GEOTECHNICAL UPDATE REPORT SR 443 Delaware Avenue Landslide Elsmere, New York

JUNE 26, 2000

**GEOTECHNICAL UPDATE REPORT
SR 443 LANDSLIDE
ELSMERE, NEW YORK**

PHOTOS JUNE 15, 2000 SR 443 DELAWARE AVE. LANDSLIDE ELSMERE, NEW YORK	DATE
	JUN 2000
	JOB NO.
	1280
	FIG.
	1

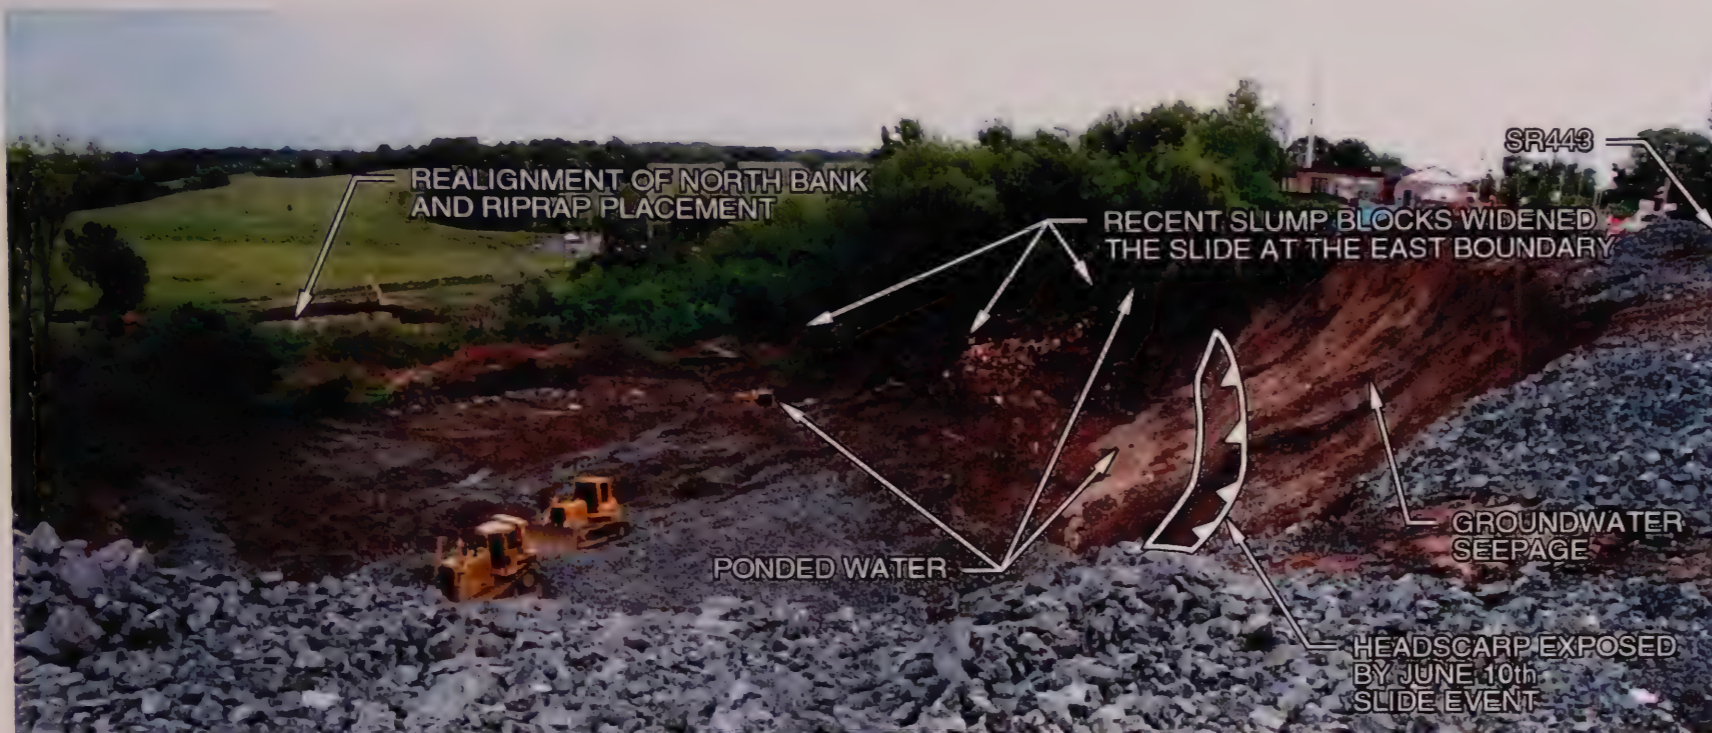
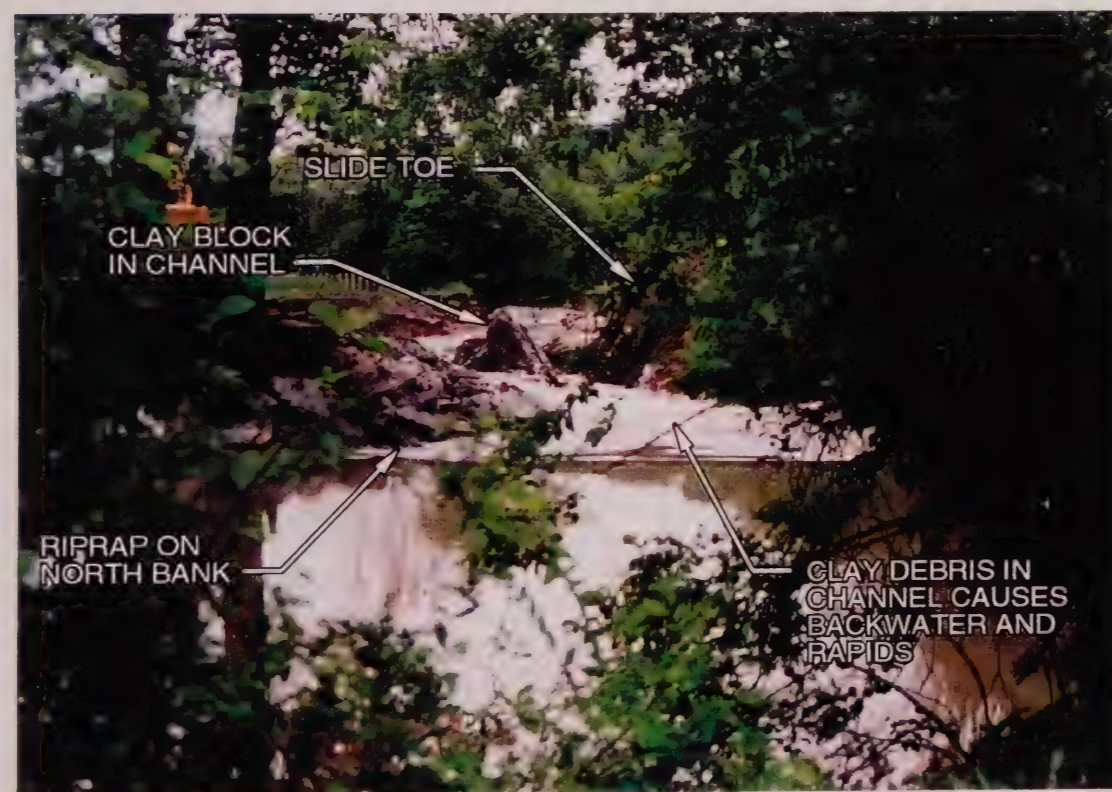
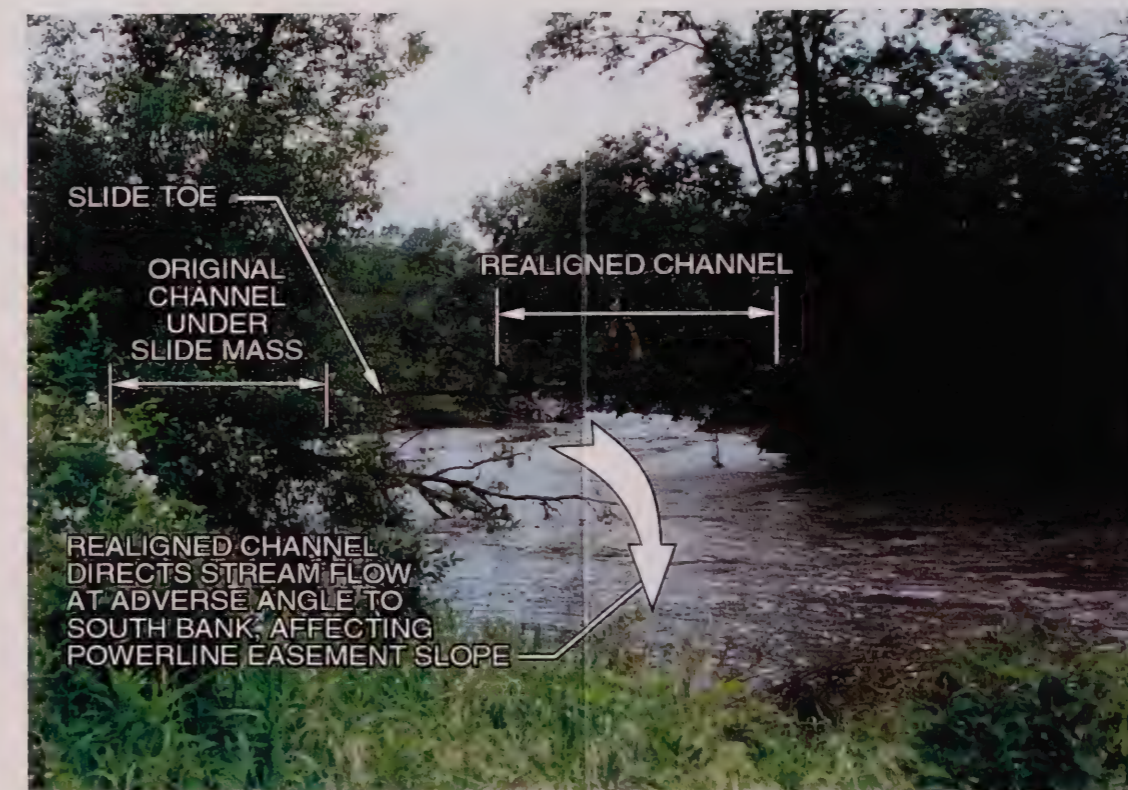
1. We performed a geotechnical reconnaissance of the enlarged slide area on June 15, 2000. The landslide headscarp, toe, and sidescarps were traversed. Also, the slope to the east of the slide was walked to look for slide features. The main landslide had enlarged to the east about 20 to 40 feet, where new slumps were evident. This area had been identified in our previous reconnaissance as being marginally stable, with tension cracks extending east from the main slide sidescarp and several slump blocks in a partial state of collapse. Figure 1 presents photos showing some of the new slide features.

8. The City of Albany's contractor was removing slide debris from the stream channel and was placing additional riprap. The stream channel alignment was irregular because of slumped and eroded materials from the toe of the slide, and from excavations for new riprap, which extended further north midway along the slide-impacted section of stream bank. Photos of the stream channel conditions are shown on Figure 1.

TITLE **SITE PLAN: RECOMMENDED
INSTRUMENTATION**

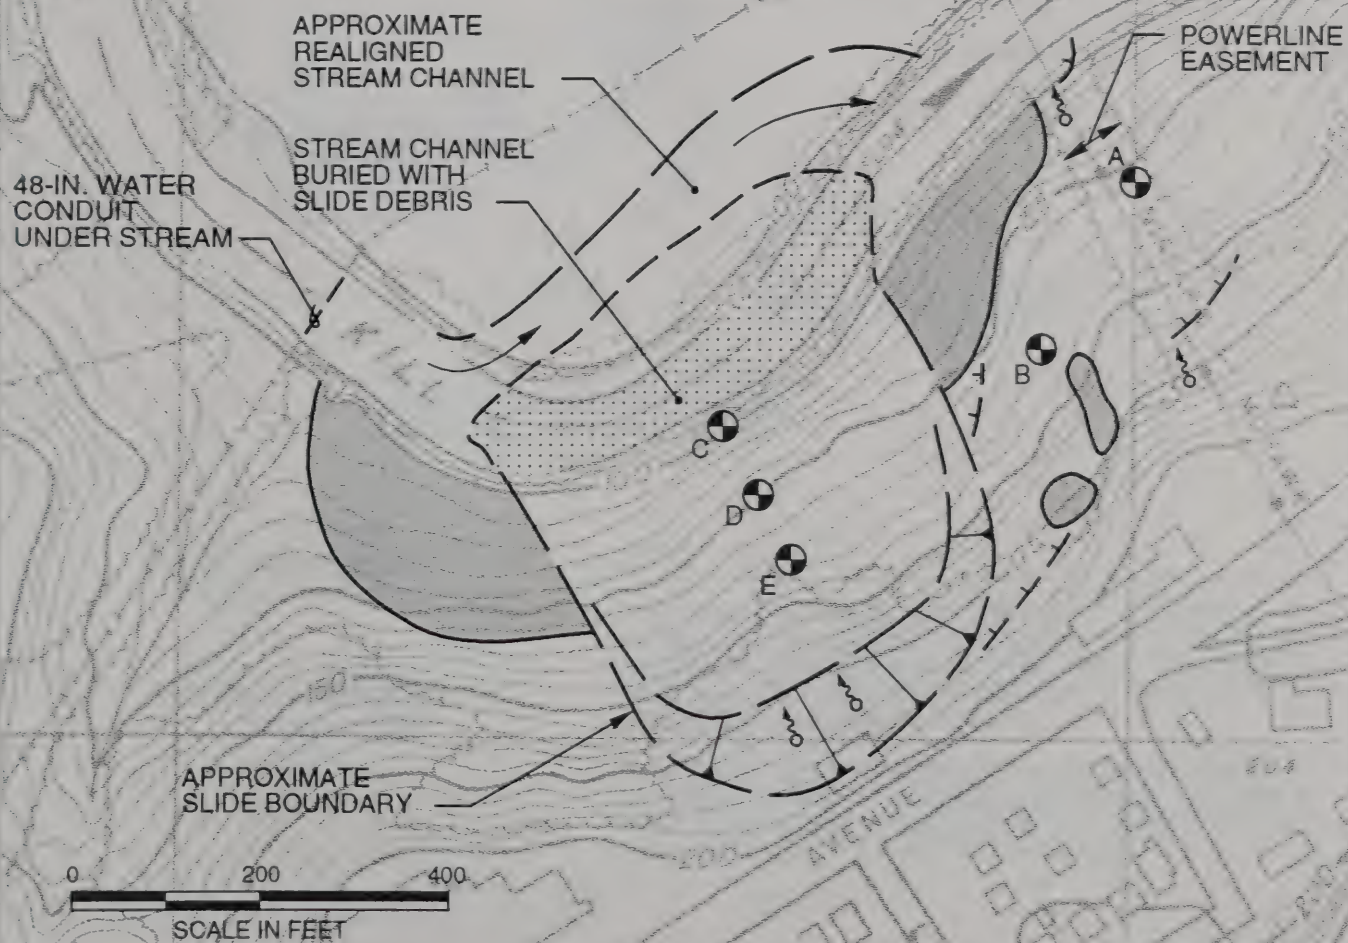
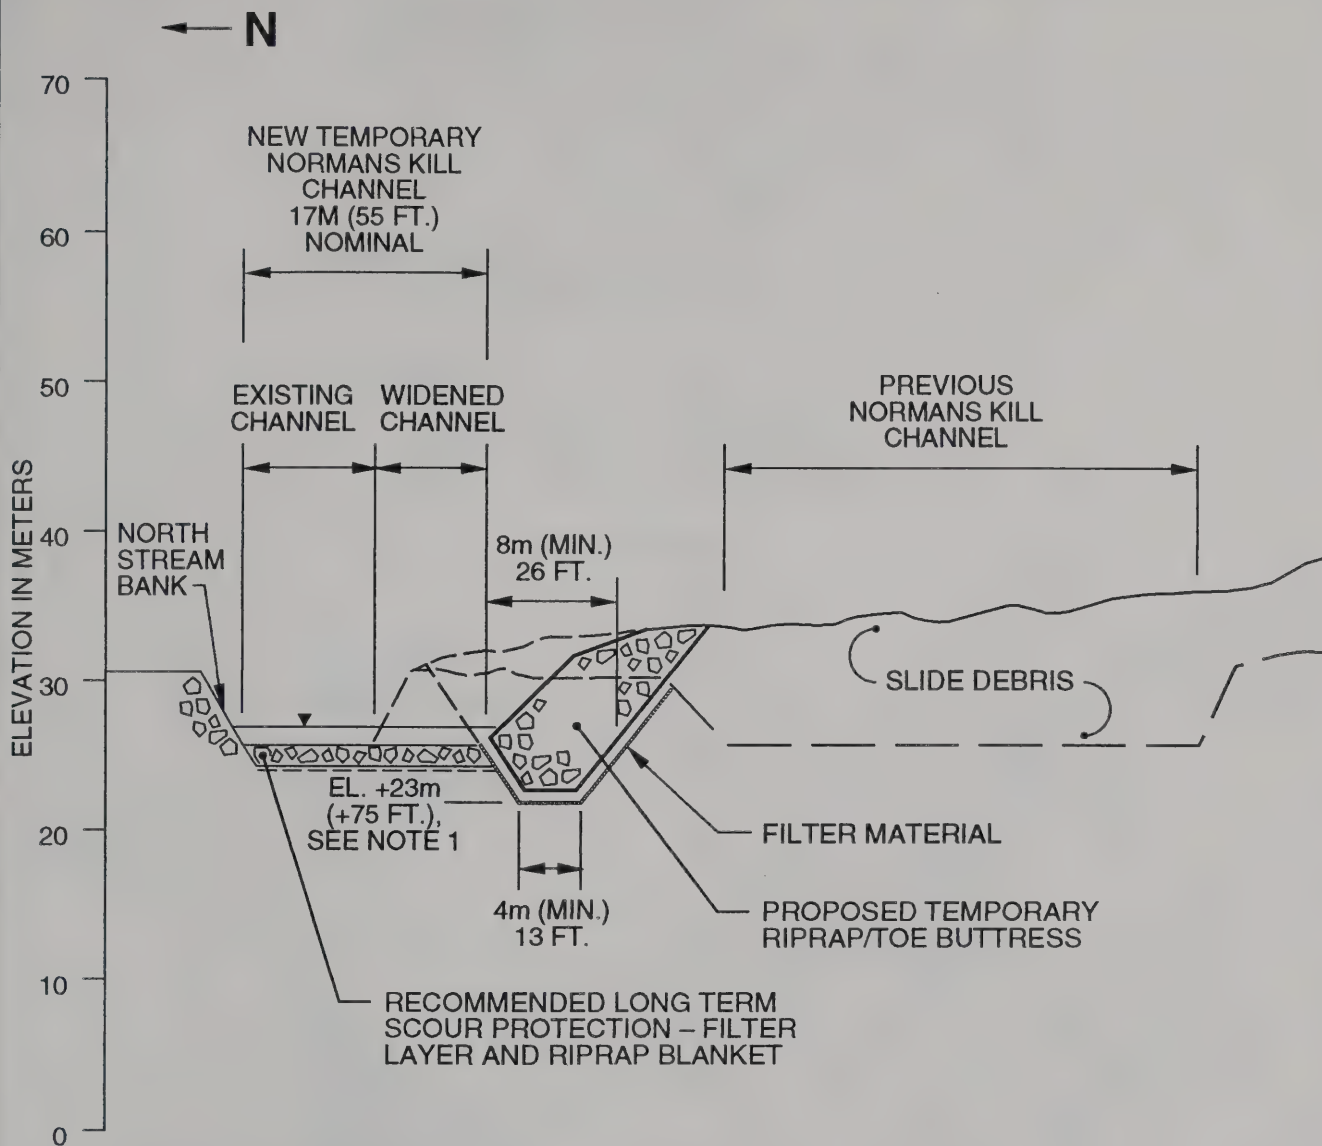
3. Install and monitor inclinometer casing within the lower area of the active slide mass. Inclinometer installations to the east of the main slide, at mid-slope, are also recommended, as shown on Figure 2. The areas include the Jiffy Lube property and the powerline easement, where both appear to be experiencing slide

TITLE
**RECOMMENDED PIEZOMETERS
TO MONITOR DRAWDOWN**
JOB
SR 443 DELAWARE AVE. LANDSLIDE
ELSMERE, NEW YORK

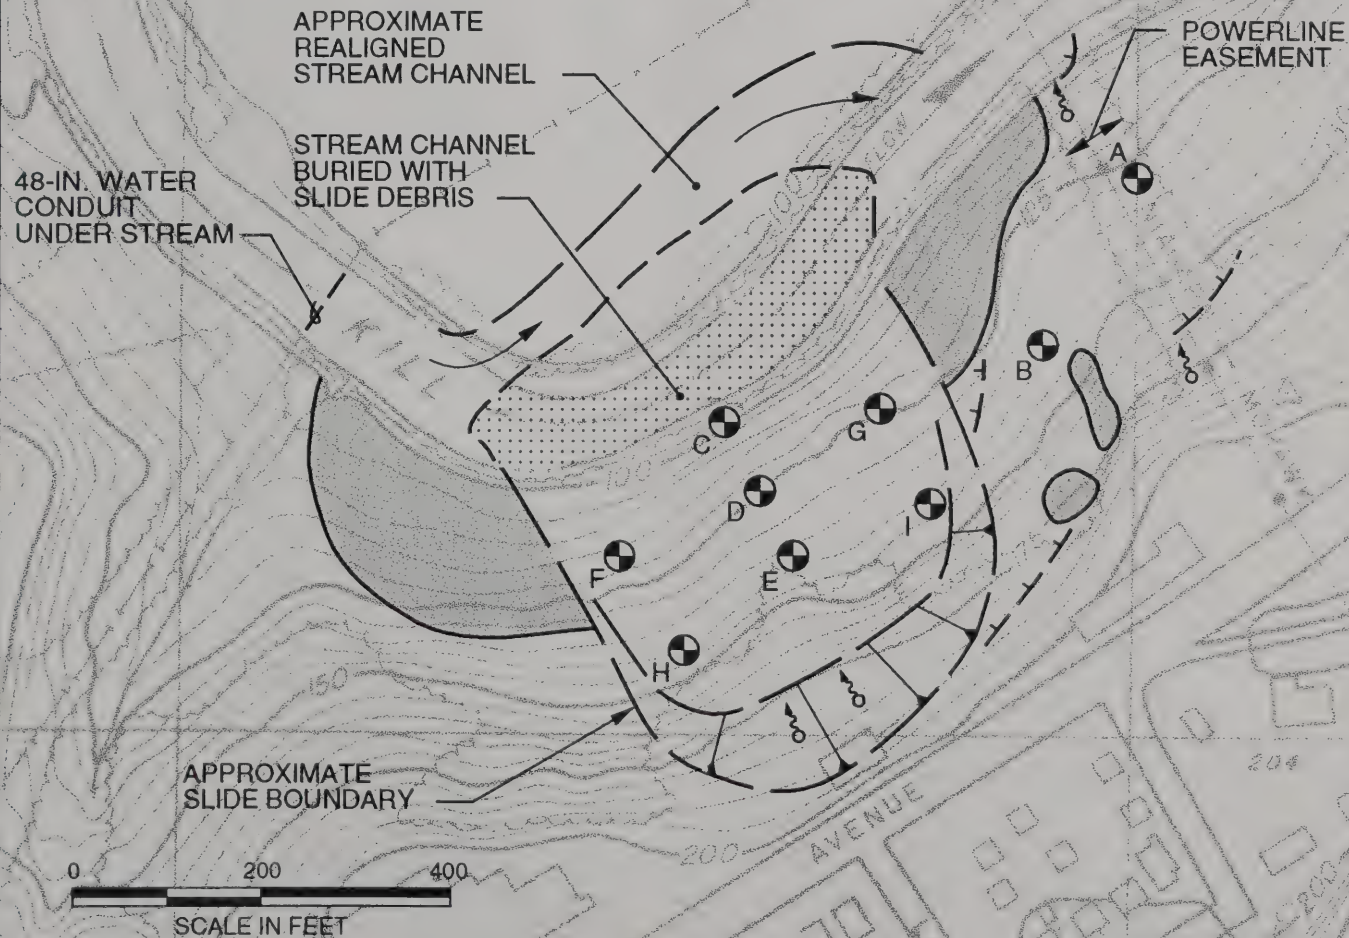
16. Piezometer instrumentation and monitoring will be critical to determining the adequacy of the drainage system. The instruments should be spaced apart across the slide mass, on a grid pattern, to verify that groundwater lowering objectives have been met. A preliminary program of additional monitoring piezometers is shown on Figure 4. At present, the depth of the slide plane is still being investigated. Therefore we recommend that dual piezometers be installed to bracket the interpreted range of slide depth.
